**TSG-RAN Meeting #13
Beijing, China, 18 - 21 September 2001**

RP-010538

Title: Agreed CRs (Release '99 and Rel-4 category A) to TS 25.303

Source: TSG-RAN WG2

Figure 37: Combined Hard Handover and SRNS relocation (seamless radio bearers)

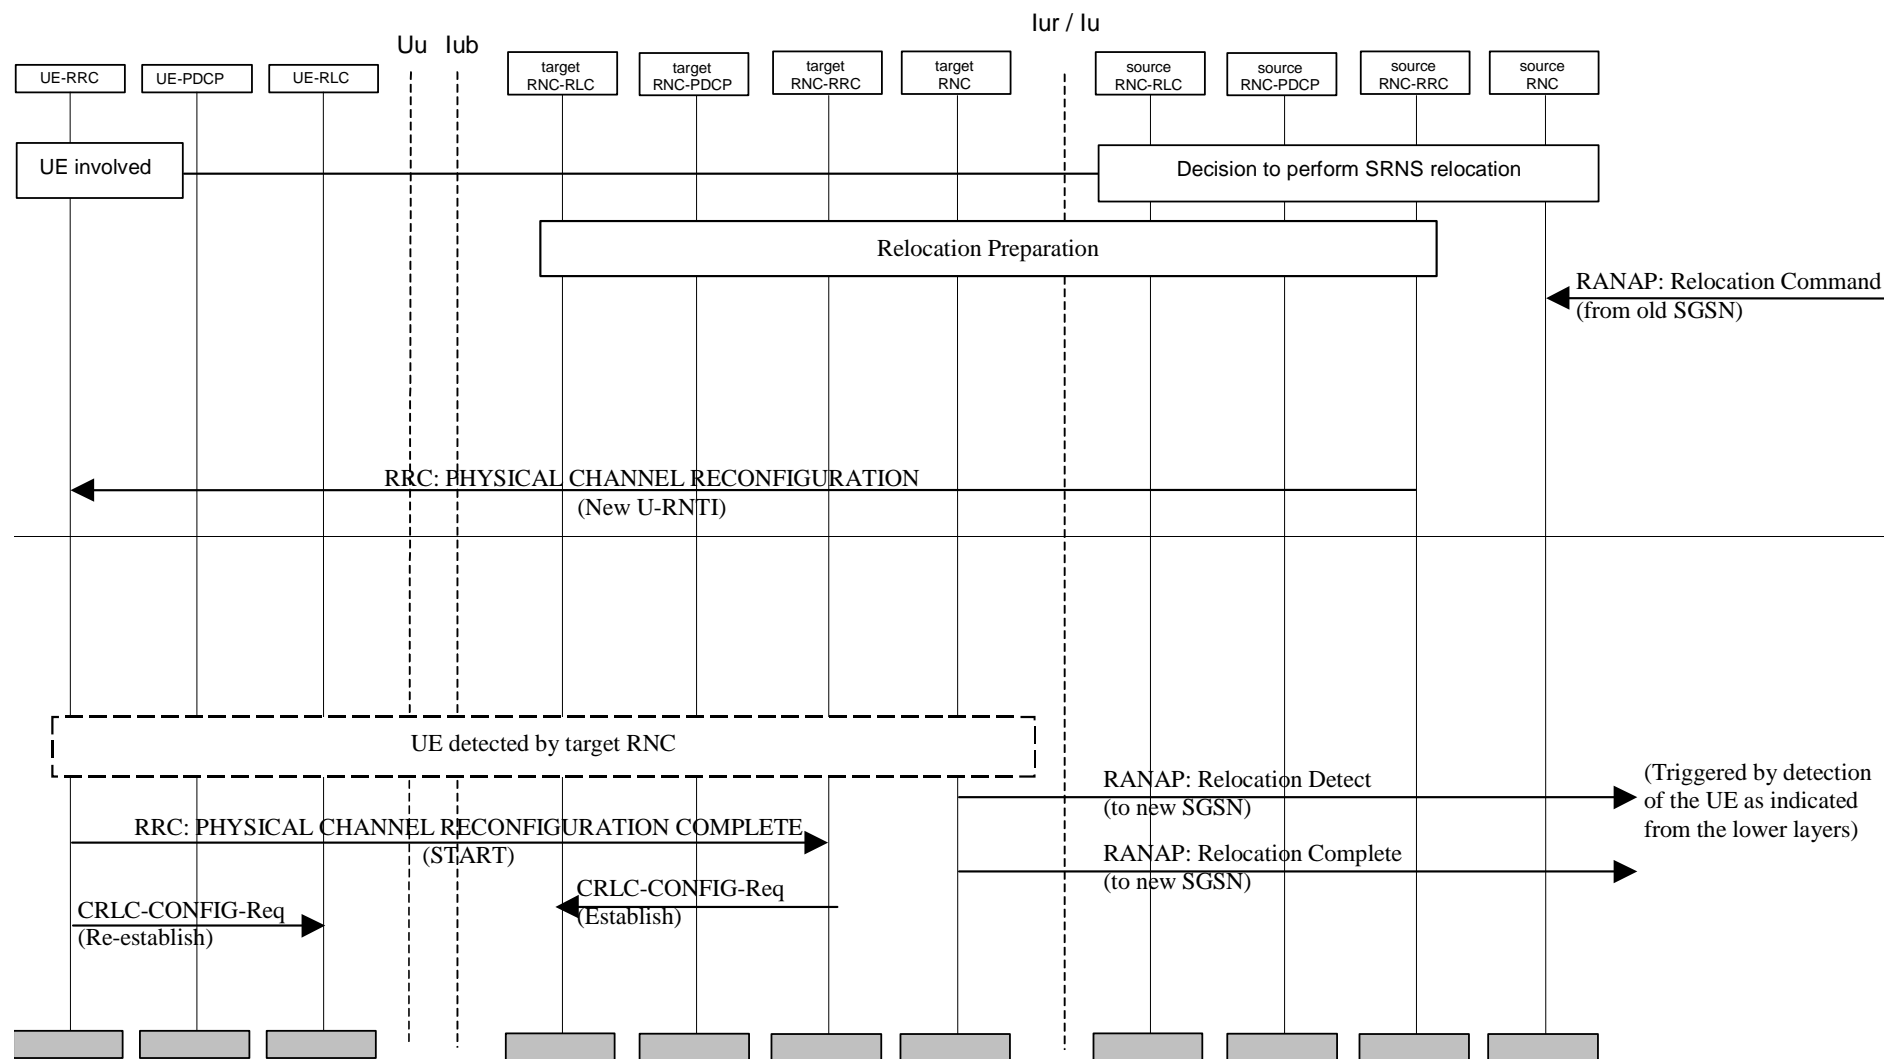
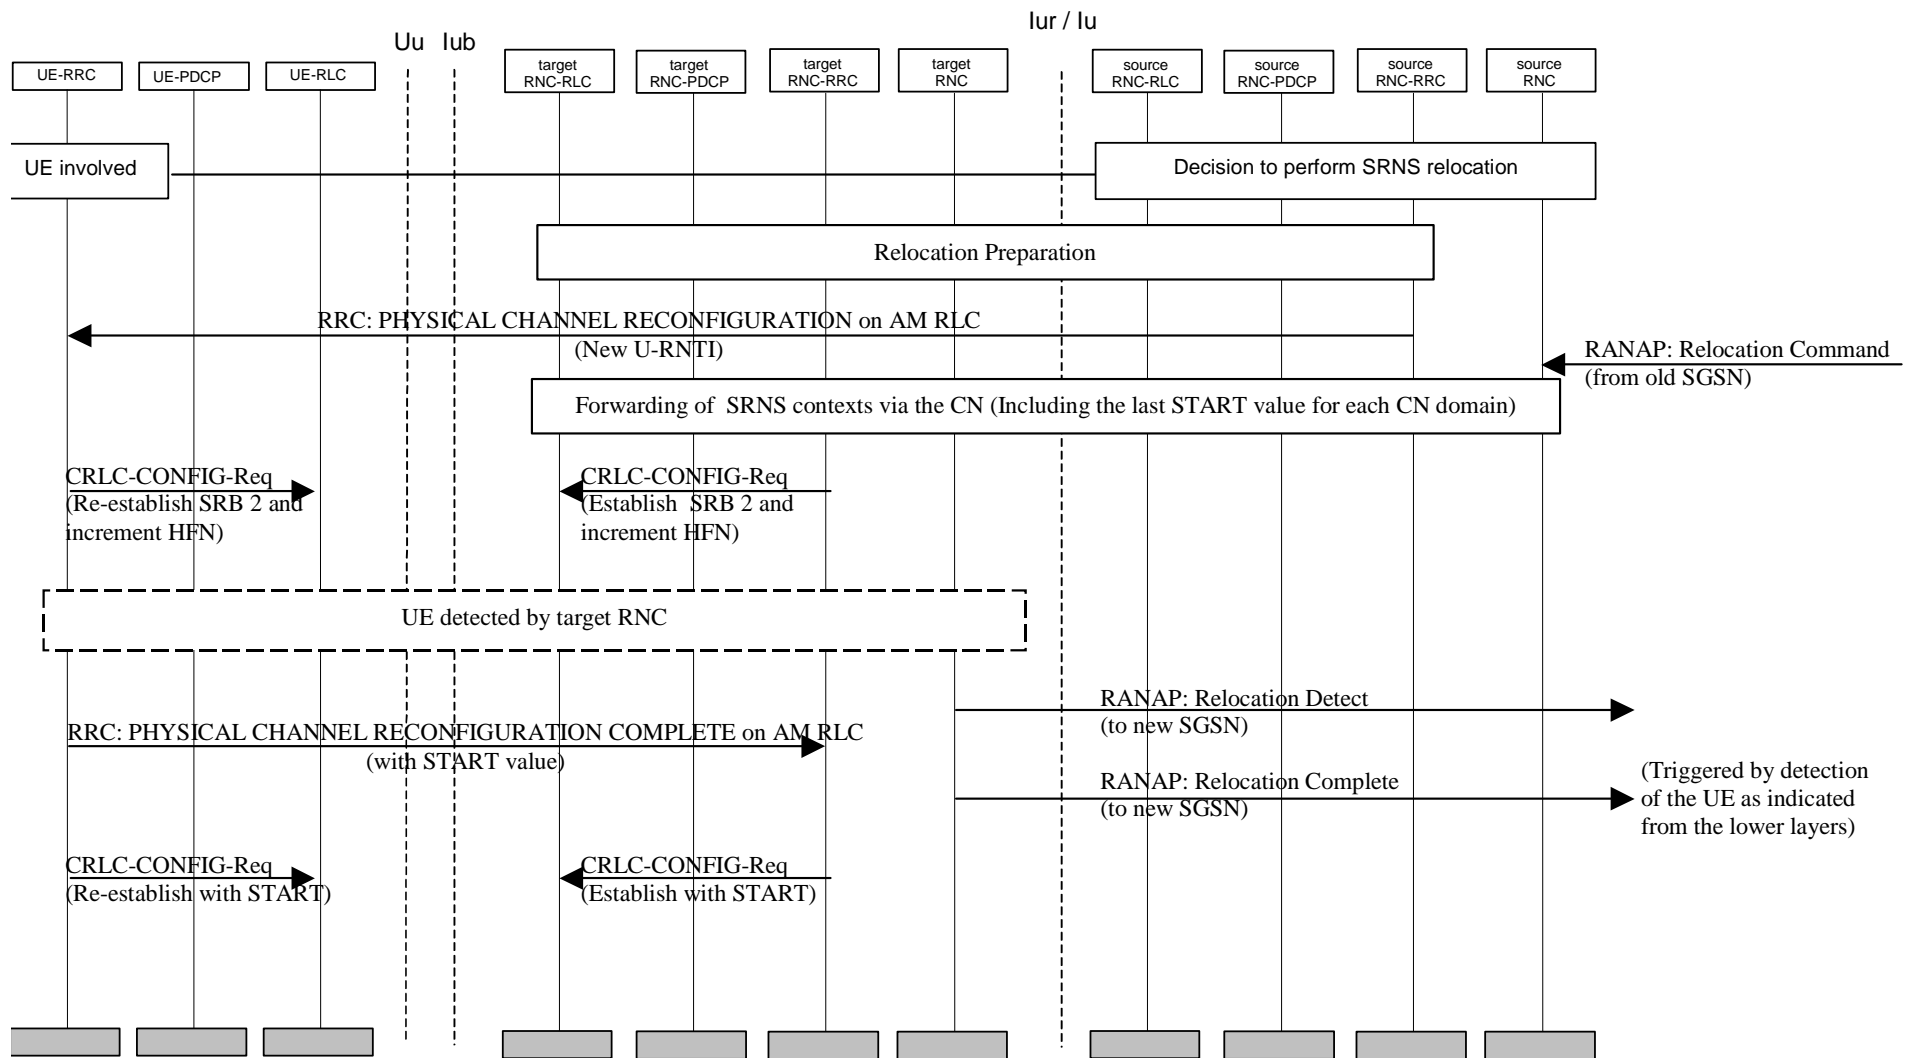
Reason for change:	⌘ In the way the current description is specified, it is not possible for the target RNC to receive the uplink response from the UE since the RLC state was lost during SRNS relocation. For this message to go through, at least the RB on which the message needs to be re-established using a START value that is known both at the UE and in UTRAN.
Summary of change:	⌘ It is suggested to perform RLC re-establishment of SRB2 before transmitting the response on the uplink. Then, after the response message is transmitted, to use the START value transmitted in this message to re-establish the rest of the RBs and SRBs. This change affects lossless and seamless SRNS relocation in CELL_DCH.
Consequences if not approved:	⌘ SRNS relocation, lossless or seamless will not work in dedicated mode.

If the UE has successfully configured itself, it shall send a response message, in this case PHYSICAL CHANNEL RECONFIGURATION COMPLETE message to the target RNC using the acknowledged mode dedicated signalling radio bearer (SRB #2). This message will beis transmitted based on the new RLC context and; contains the START values (to be used in integrity protection and in ciphering on radio bearers using UM and AM RLC).

Upon acknowledgement of the message, the RLC entities for the rest of the affected radio bearers are re-establishedFor the affected radio bearers, the RLC entity is re-established [2] both on the UTRAN and UE side. The HFN values for each RB are set to the START value in the message for the corresponding CN domain. with the current configuration. The HFN values for each remaining signalling radio bearers (other than SRB #2) are set to the START value in the message for the last configured CN domain.
